Nuclear Operating Company

July 16, 2008
ABR-AE-08000054

South Texas Project
Units 3 and 4
Docket Nos. 52-012 and 52-013
Response to Requests for Additional Information

Attached are responses to NRC staff questions included in Request for Additional Information (RAI) letter numbers 39 (May 12, 2008) and 49 (May 19, 2008) related to Combined License Application (COLA) Part 2, Tier 2 Sections 2.4S and 2.5S. This submittal includes responses to the following Question numbers:

Replace Figure 2.5S.1-44 with a revised version that includes lines for lineaments.

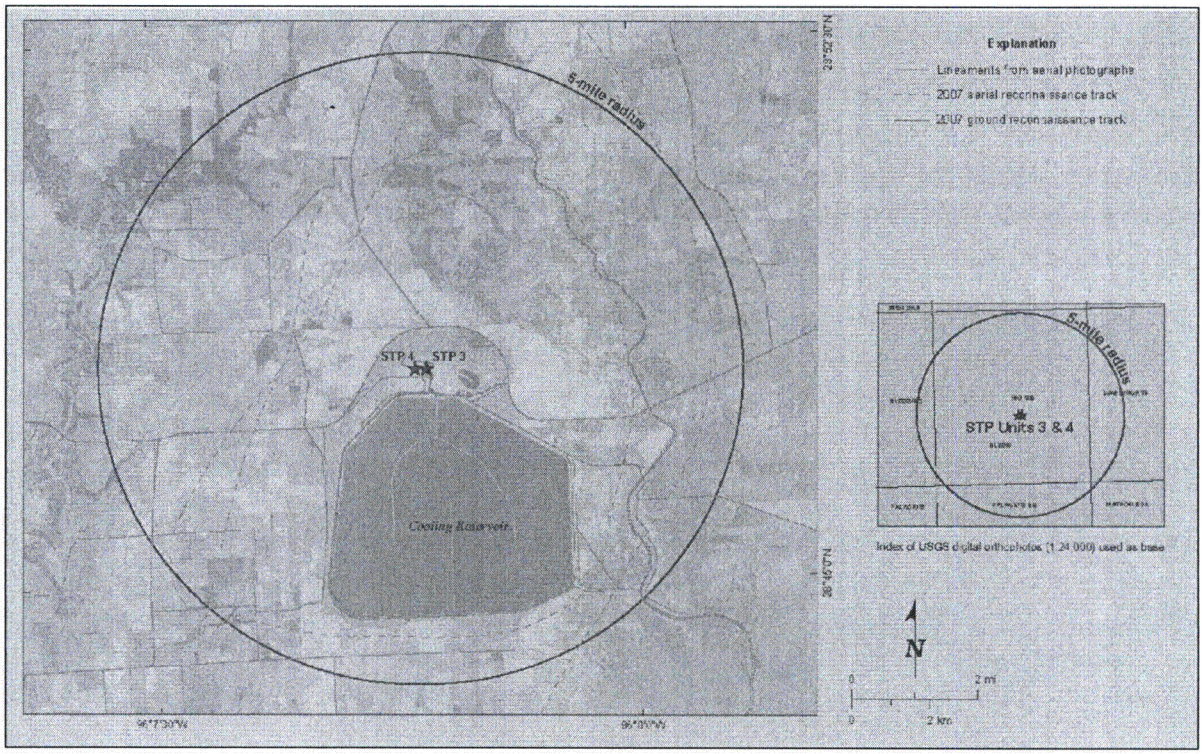
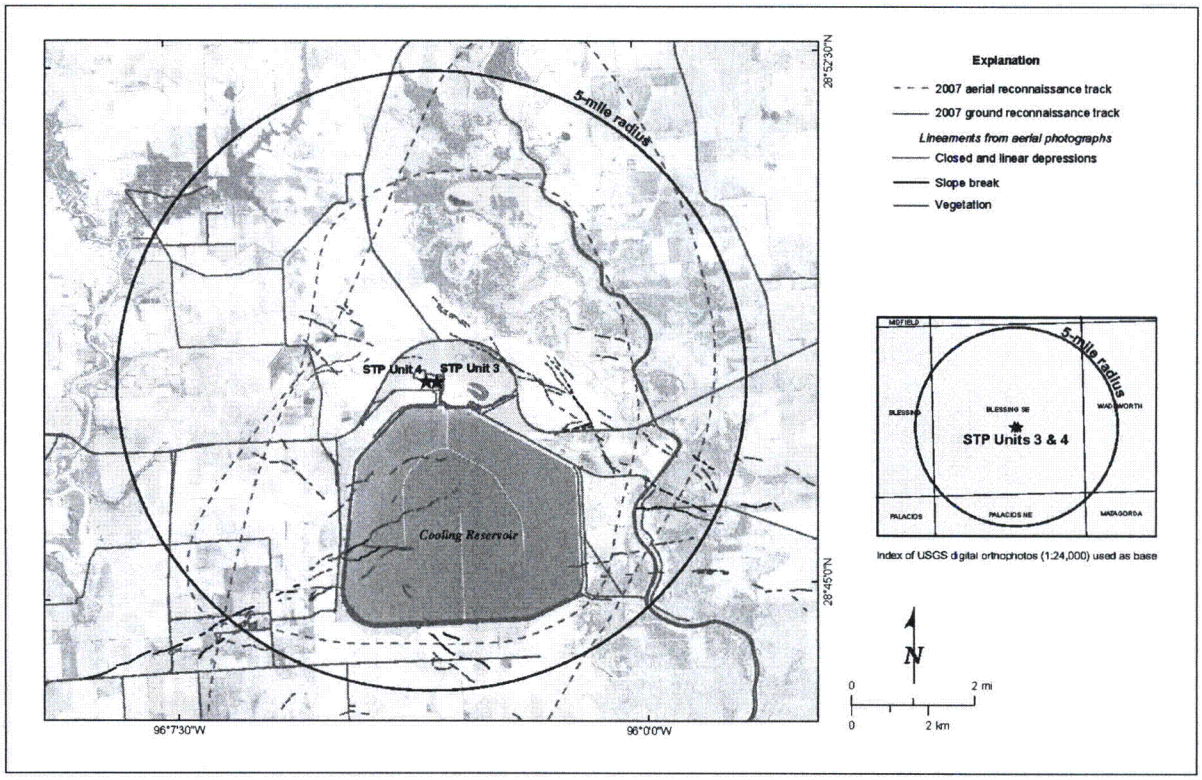
Seismic reflection, well log, and imagery data sources described in Section 2.5S.1.2.4.2.2.1 and Section 2.5S.1.2.4.2.2.1 were not capable of resolving the surface locations of growth faults. Please explain why the investigations for the STP COLA site did not include a LiDAR survey of the site area to reassess evidence for possible subtle surface folding or faulting along growth faults in the site area, particularly along the possible surface trace of fault I.

Figures 2.5S.1-44 and 2.5S.1-45 will be replaced with enhanced figures that show the location of anomalous geomorphic features (e.g., closed and linear depressions, slope breaks, vegetation lineaments) identified in the aerial photo analysis. During the analysis, particular attention was applied to identifying geomorphic features that were spatially correlated with the growth fault projections developed in the COLA and in the UFSAR for STP Units 1 and 2 (STPEGS UFSAR, Rev 13). As stated in Subsection 2.5S.1.2.4.2.2.2, the only strong spatial correlation between distinct lineaments and projected growth faults was with growth fault I/GMO (Figure 2.5S.1-45) suggesting that fault I/GMO is the only fault within the site area with a geomorphic expression of potential Quaternary activity.
